Planning Memorandum

Re: 2 Acorn Dr. – Major Site and Building Plan Review, Conditional Use Permit & Variance
WSB Project No. 027923-000

Re: 2 Acorn Drive – Major Site Plan Review
City of Sunfish Lake, MN
WSB Project No. 027923-000

Grading, Erosion Control and Restoration

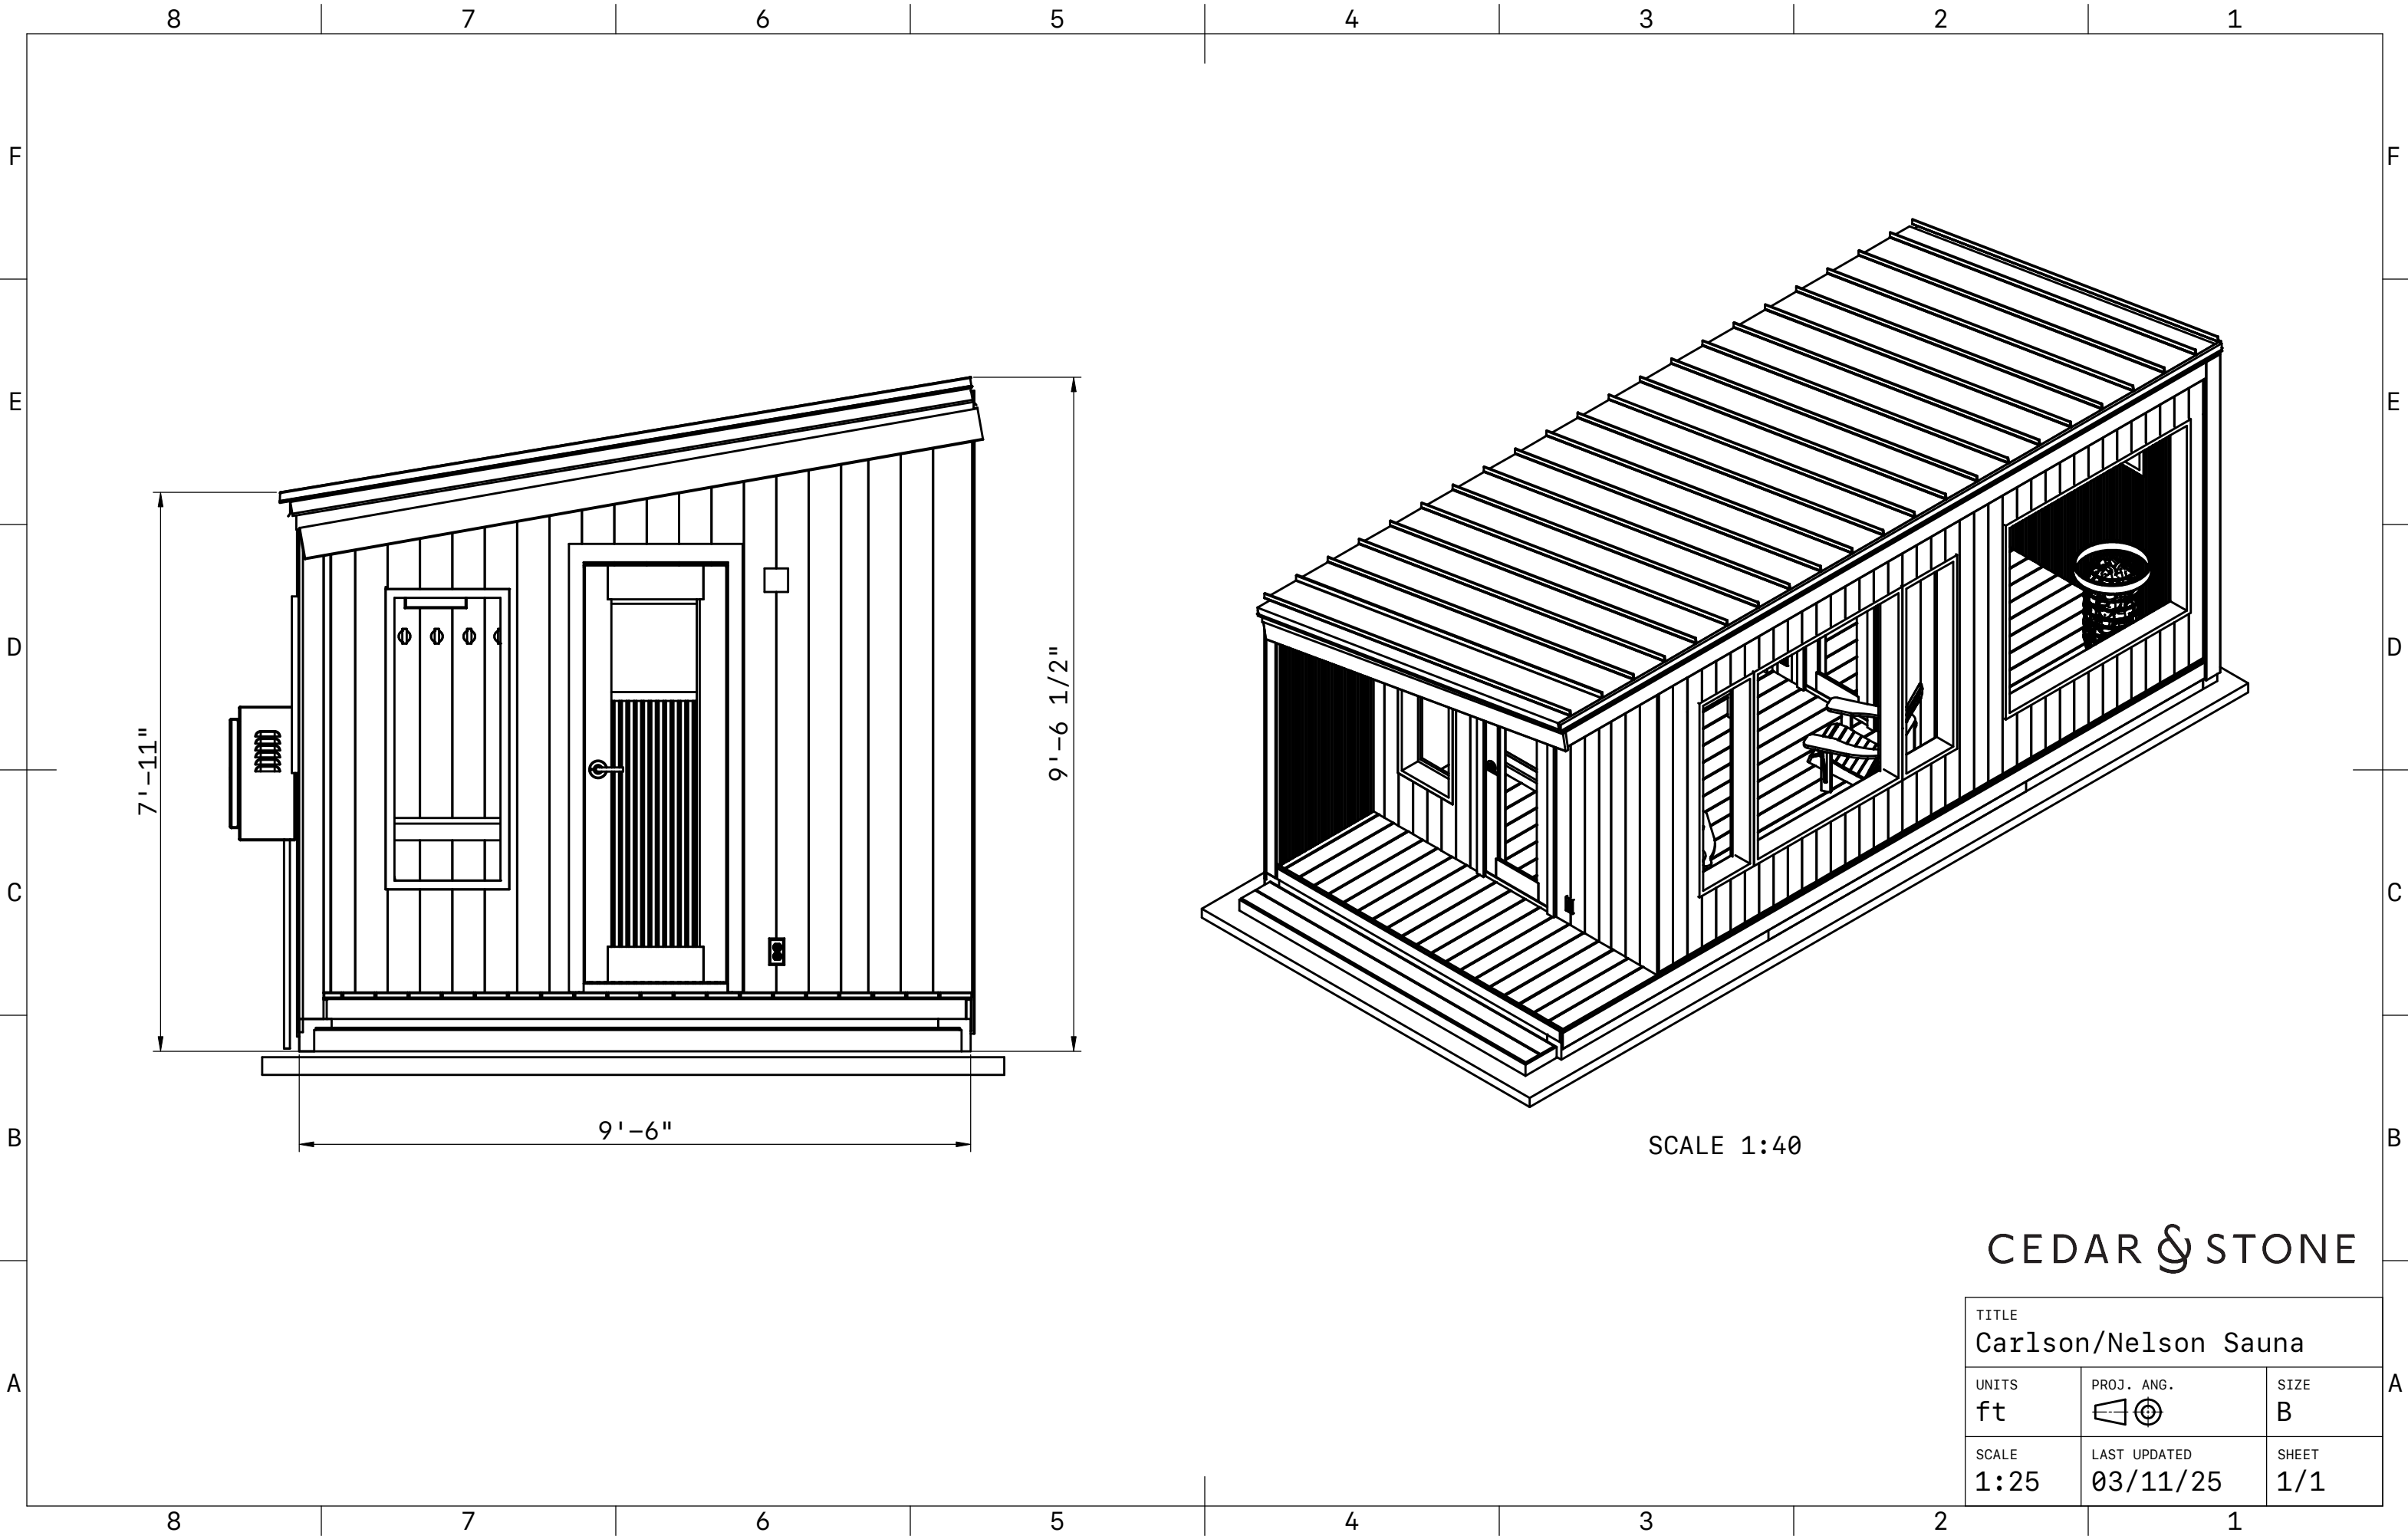
1. See the attached plan for comments related to grading throughout the site.
2. An as-built survey will be required upon project completion that demonstrates the improvements were constructed per the approved plans.

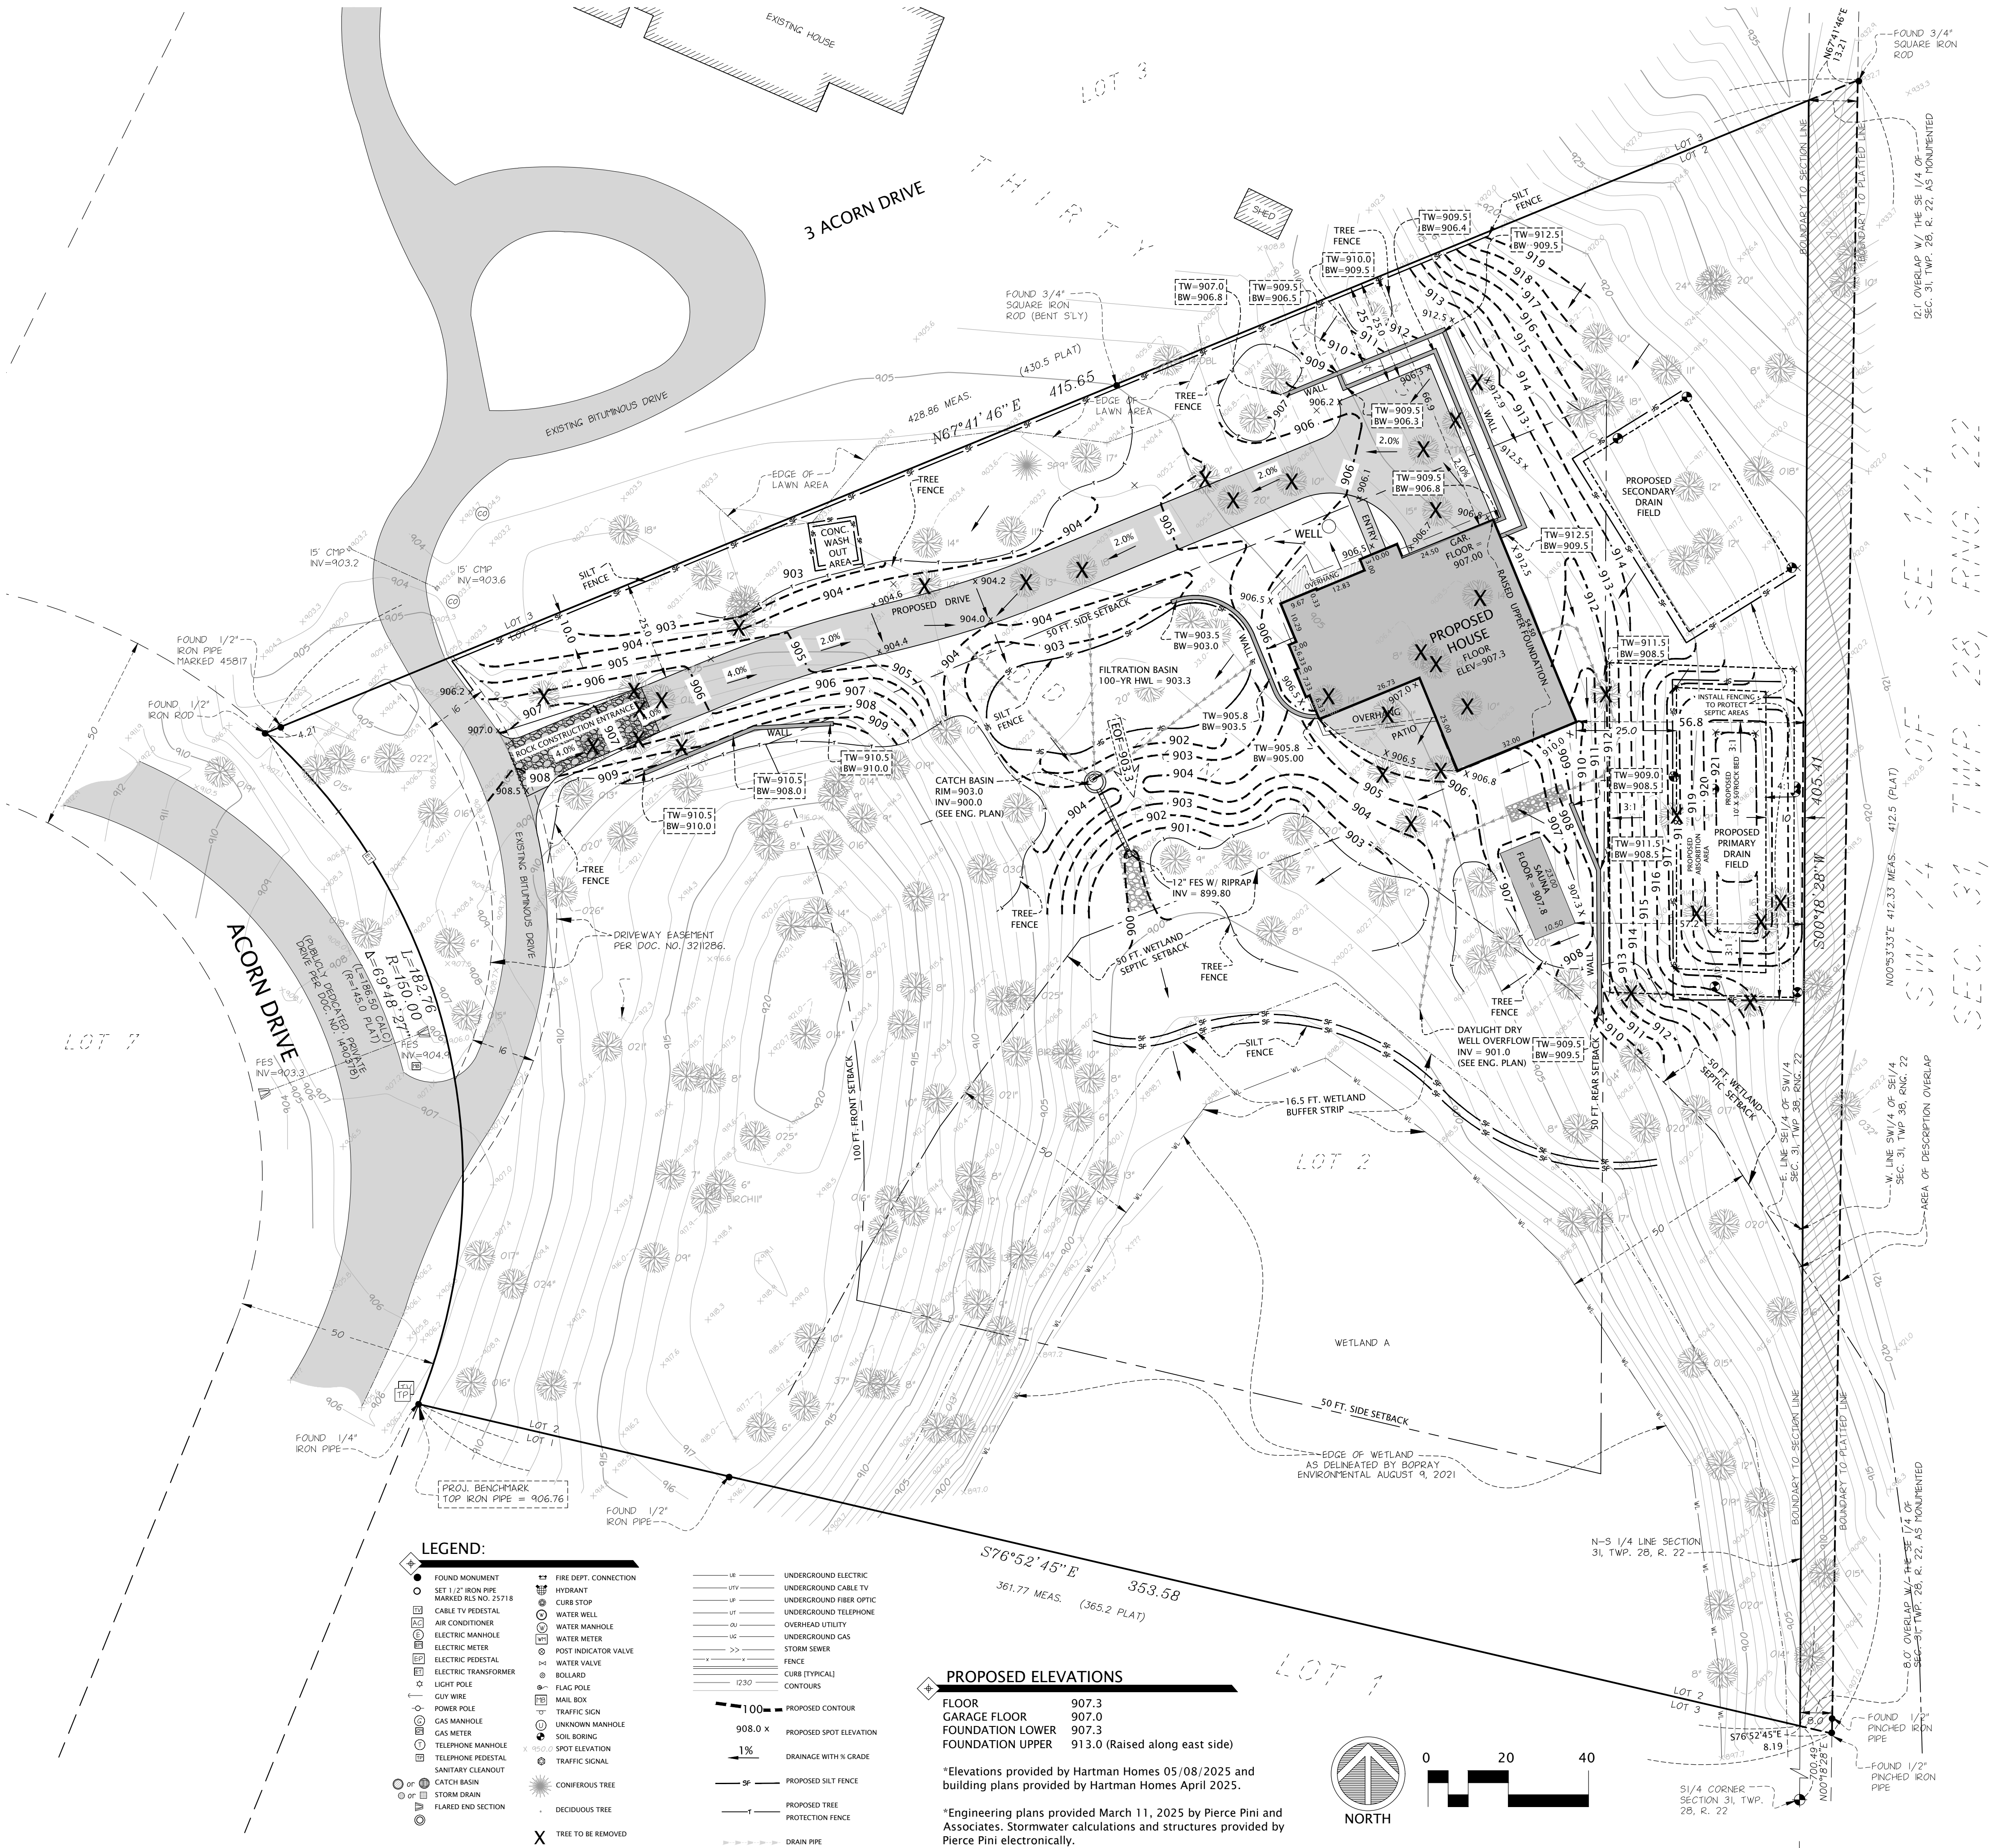
Hartman Homes Inc. is representing the owners of 2 Acorn Drive; we recently requested a driveway variance at the last planning commission meeting in May, 2025. The request was denied by the Commission, but we do not feel that they completely understood the impact that the driveway will have on the grading on the property and the loss of mature trees, if it needs to be installed at the required 25-foot setback from the North property line.

We are submitting an updated survey showing the proposed driveway at the 25-foot setback, to show how this will impact the property, compared to the 10-foot variance requested. As you can see, there will need to be major excavation to the side-slope of the hill in this location, and a proposed retaining wall, to cut-in a level driveway. Ultimately, there will be 5 mature trees removed that are in the path of the driveway (#63,64,66,71,144), and the excavation will undermine the root system, or fill over the base of 2 other trees, potentially 3 (#62,65 and probably #60) causing them to die. (Tree site plan and tree inventory was also attached for reference; these notes refer to the section of driveway that is closer than 25-feet to the lot line, a little over 1/2 of the driveway meets the 25-ft required setback nearing the neighbors home at 3 Acorn Drive)
